# INTERNATIONAL BUILDING CODE – MEANS OF EGRESS

## E1-07/08, Part II

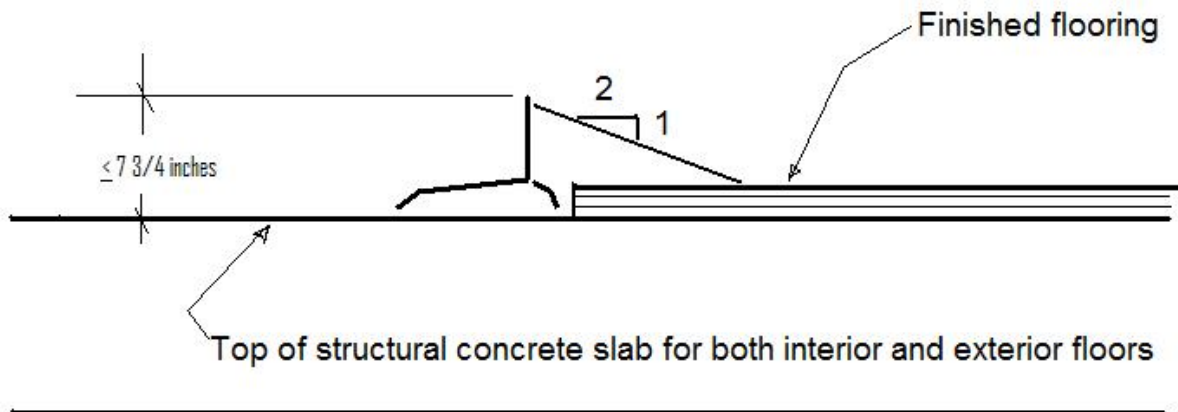
Case #2: Top of structural slab for both interior and exterior floor is at the same elevation. Only difference in floor height is from the interior finished flooring. Entire water barrier must be provided by the door threshold, which is permitted to be up to 7 3/4 inch in height by the exception to 1008.1.6.

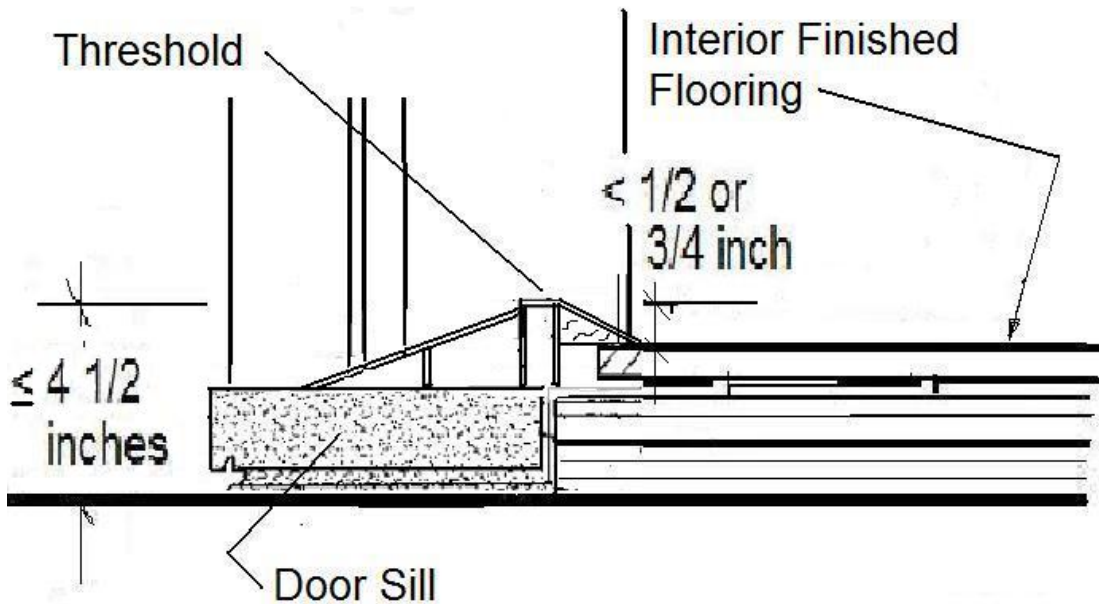
Case 3 (as proposed): The threshold exceeds 1/2 or 3/4 inch in height, but the top of the threshold is not more than 1/2 or 3/4 inch above the interior floor surface. The remainder of the height difference occurs in the difference in height between the interior and exterior floors. A trim piece is provided between the interior floor and the top of the threshold, with a slope that does not exceed 1 unit vertical to 2 units horizontal.

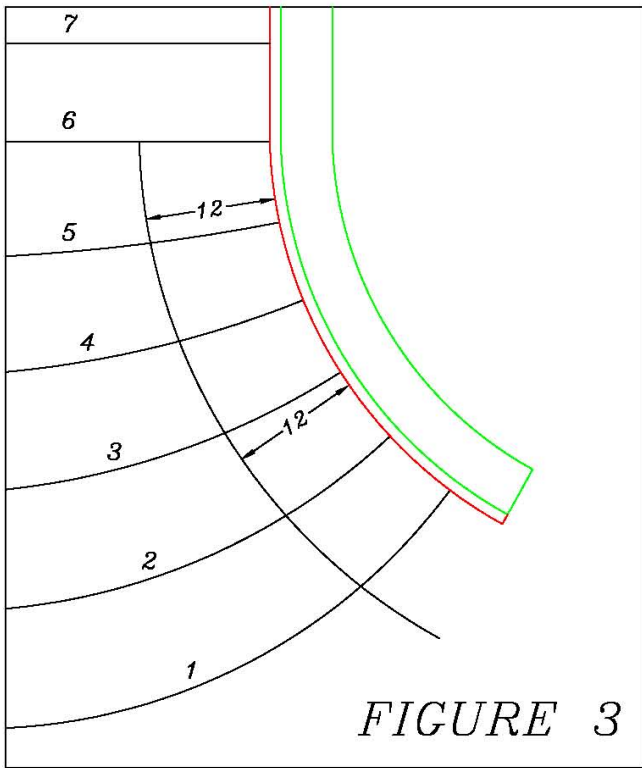
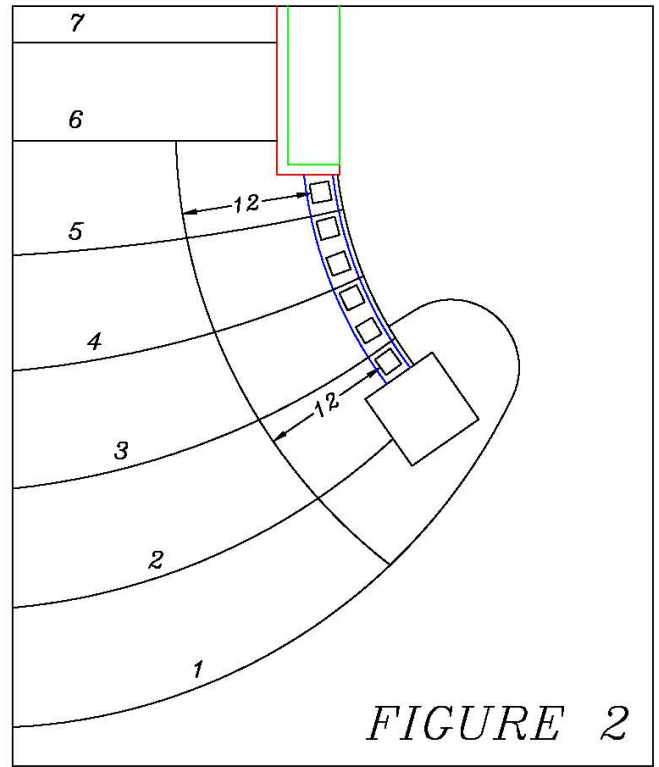
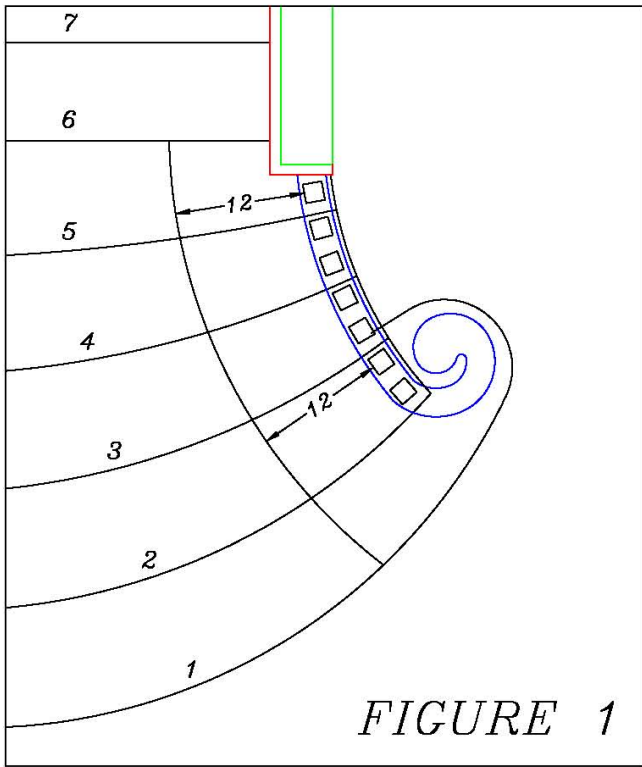
The IRC committee had issues with the terminology “used for placement of the foot...” and that has been stricken. The new section titled walk line states clearly and specifically how to locate the walk line at winder treads where it is used to determine the tread depth of winder tread(s) that provide for turning of the stair’s direction of travel. This line of travel across winders is a curved path and the walk line established for regulation must parallel it. The term concentric is used because it more accurately describes the geometry of parallel arcs or curves sharing the same center. This separate section substantiates this essential element required in the design and construction of stairs that turn. It further provides clarity for regulating its location that is not subject to the wide interpretation of the present code and thereby allows for the direct reference to walk line in subsequent sections of the code. Please also see the original supporting statement for further substantiation of these changes.

1. Locate the side of the stair where the winder treads are narrower
2. Establish the widest point of clear width of the stair at the surface of the winder or run of adjacent winders
3. Measure across the stair width 12 inches from the object that restricts the clear width at the tread surface
4. Measure tread depth between the intersections of the nosings with the walk line.

Figures 1,2, & 3 show common walk line locations as determined by the modification. The walk line, balusters, post, and tread nosings are in black. The wall is green and the skirt board or finish stringer is in red.

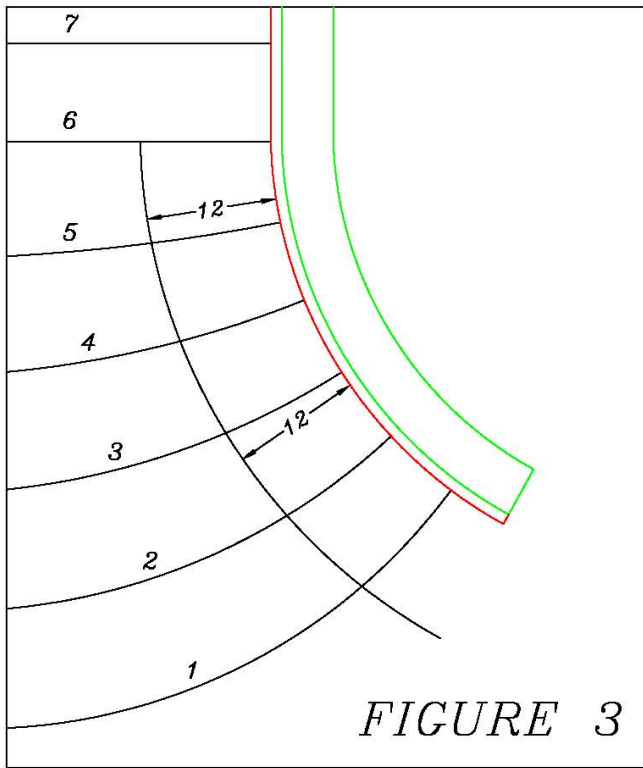
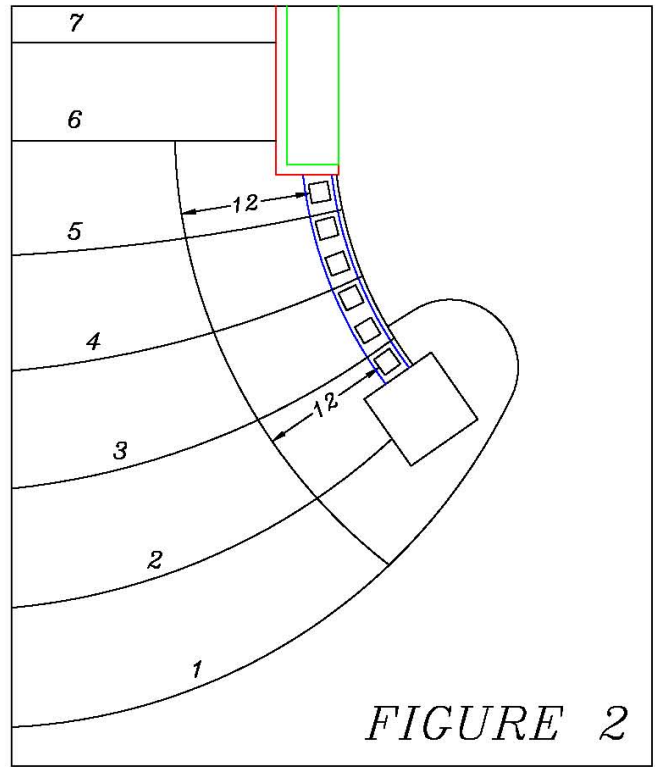
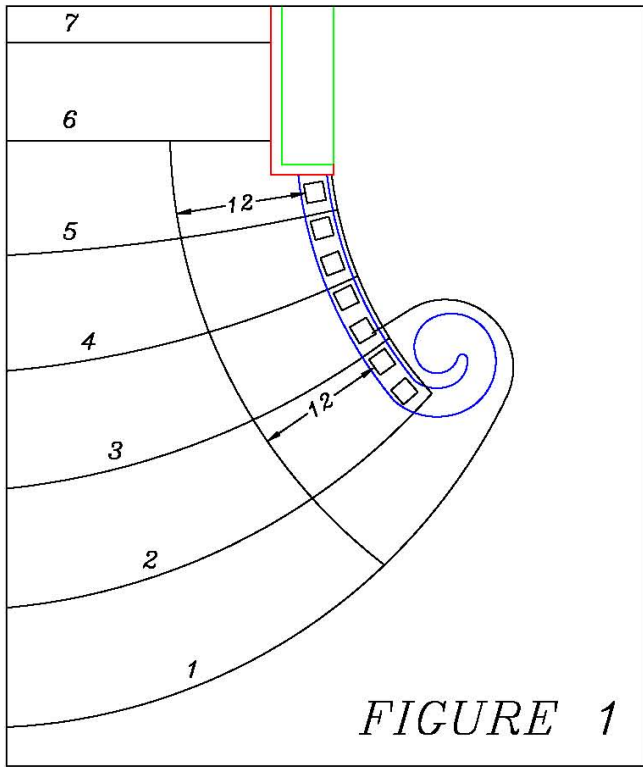
The IRC committee had issues with the terminology "used for placement of the foot..." and that has been stricken. The new section titled walk line states clearly and specifically how to locate the walk line at winder treads where it is used to determine the tread depth of winder tread(s) that provide for turning of the stair's direction of travel. This line of travel across winders is a curved path and the walk line established for regulation must parallel it. The term concentric is used because it more accurately describes the geometry of parallel arcs or curves sharing the same center. This separate section substantiates this essential element required in the design and construction of stairs that turn. It further provides clarity for regulating its location that is not subject to the wide interpretation of the present code and thereby allows for the direct reference to walk line in subsequent sections of the code. Please also see the original supporting statement for further substantiation of these changes.

- 1, Locate the side of the stair where the winder treads are narrower
- 2, Establish the widest point of clear width of the stair at the surface of the winder or run of adjacent winders
3. Measure across the stair width 12 inches from the object that restricts the clear width at the tread surface
4. Measure tread depth between the intersections of the nosings with the walk line.

Figures 1, 2, & 3 show common walk line locations as determined by the modification. The walk line, balusters, post, and tread nosings are in black. The wall is green and the skirt board or finish stringer is in red.

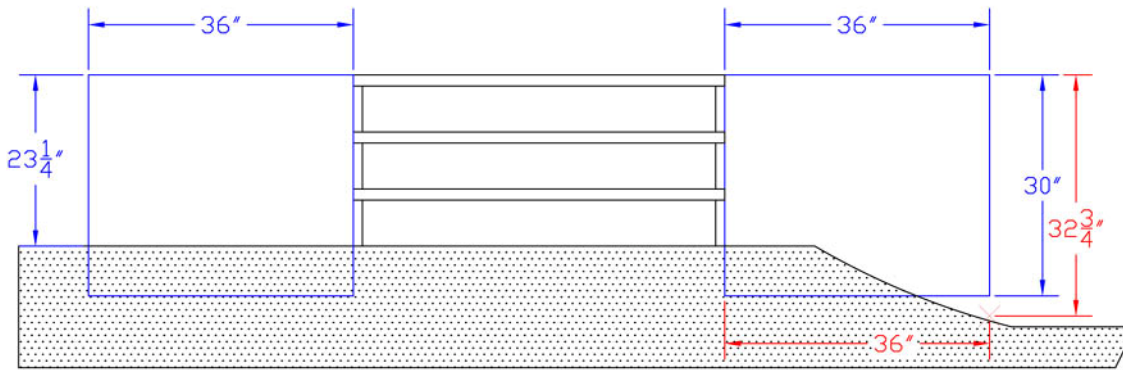
The key part of this change to IBC 1013.1 is submitted in order to clarify how the height measurement which triggers the guard requirement is made relative to proximity to the adjacent fall-off. This is illustrated in the following figure:

The view is taken from the landing of a 3 riser stair, looking towards the face of the risers.
